Engineering Change Notification

R256 Microstepping Driver/Controller Heat Sink update

ECN No: 32699

Visual Differences to the Heat sink

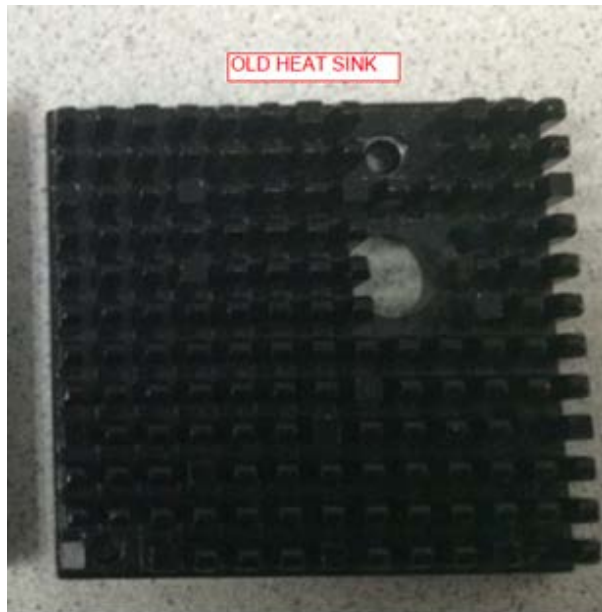
The height thickness is reduced from 0.41" (10.5mm) to 0.35" (8.8mm). The heat sink fins change as pictured below. All existing features still stay the same.

Old Heat Sink Design(53.39°C Max/ Steady State)

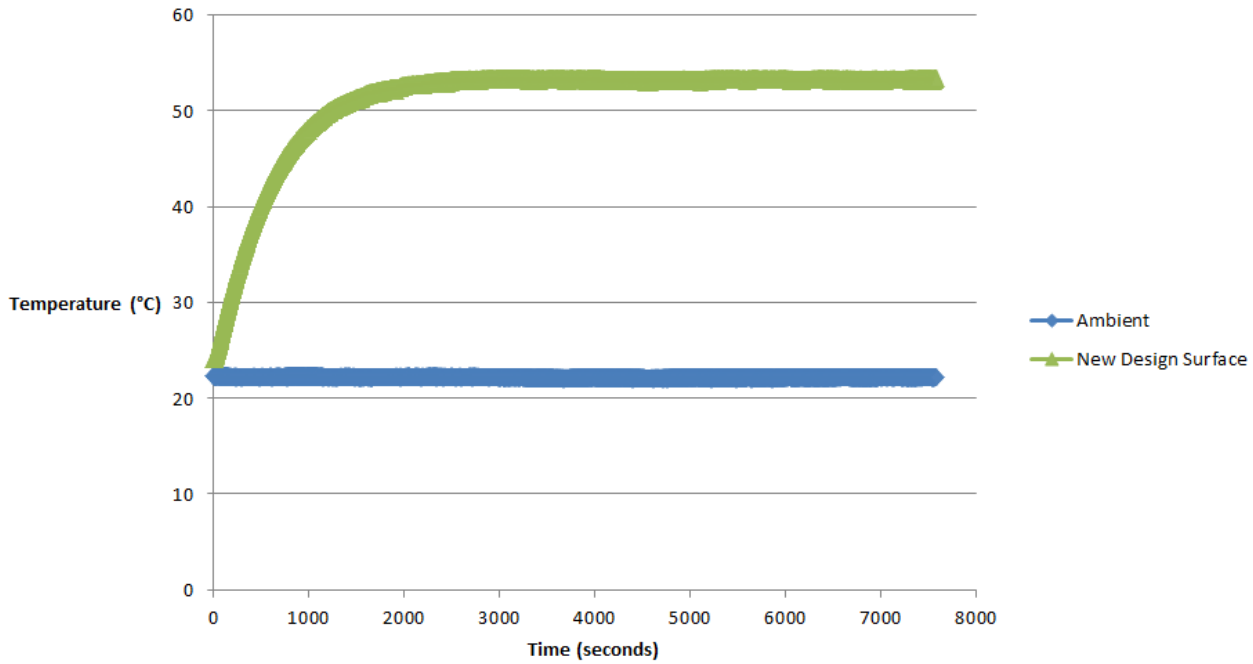
The old R256 heatsink was tested in an oven set to 53.39°C ambient temperature. The R256 was operating a standard NEMA 17 step motor. Below is the temperature rise over time:

New Heat Sink Design(52.61°C Steady State)

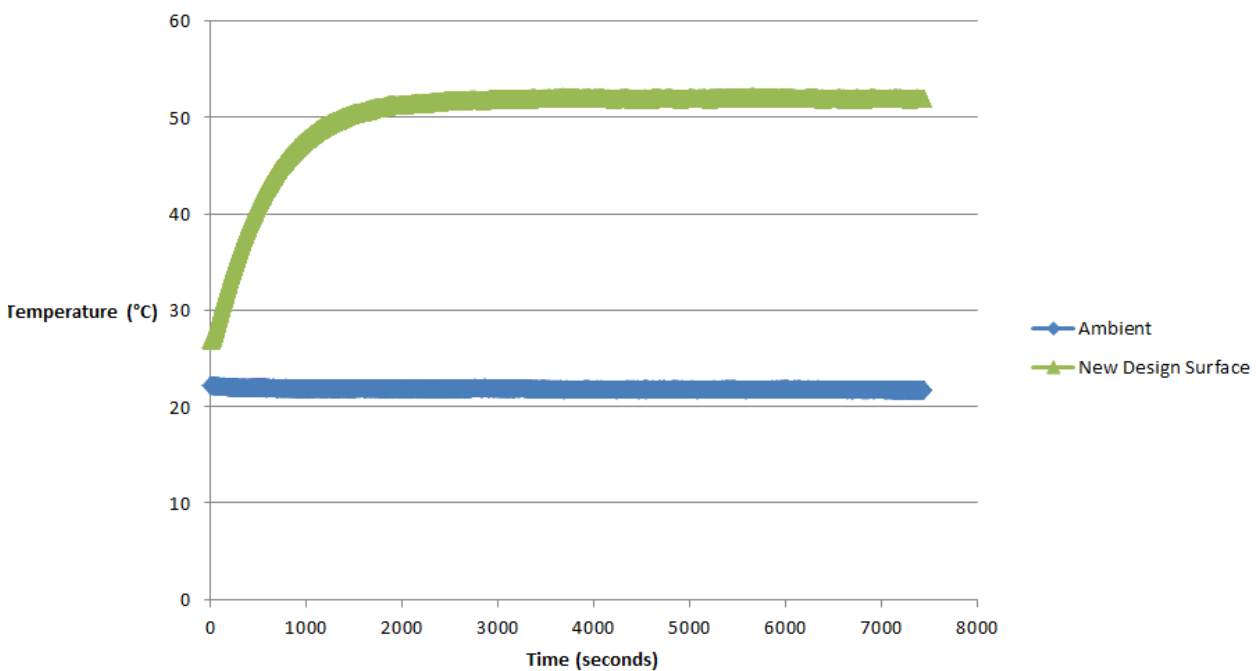
The new R256 heatsink was also tested in an oven set to 52.61°C ambient temperature while operating the same NEMA 17 step motor as the above test. Below is the temperature rise over time:

Both the old and the new heatsink possess the same heat dissipation and therefore will not pose any differences in performance when switching from the old design to the new design.
